## Installation Instructions

## NGX Ultra Computer Core Replacement Kit Kit #26723301

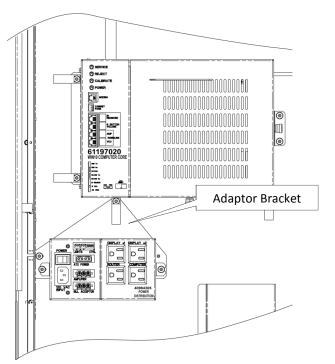
The VGA and HDMI ports on the I/O panel of the 61197020 Computer Core are located in a different position than previous Computer Cores. The video cables that plug into the VGA and HDMI ports will interfere with the Power Distribution Unit in the NGX Ultra when installing a 61197020 Computer Core.

In addition to the new Computer Core, this kit contains the bracket required to relocate the Power Distribution Unit slightly lower in the cabinet providing clearance for the video cables.
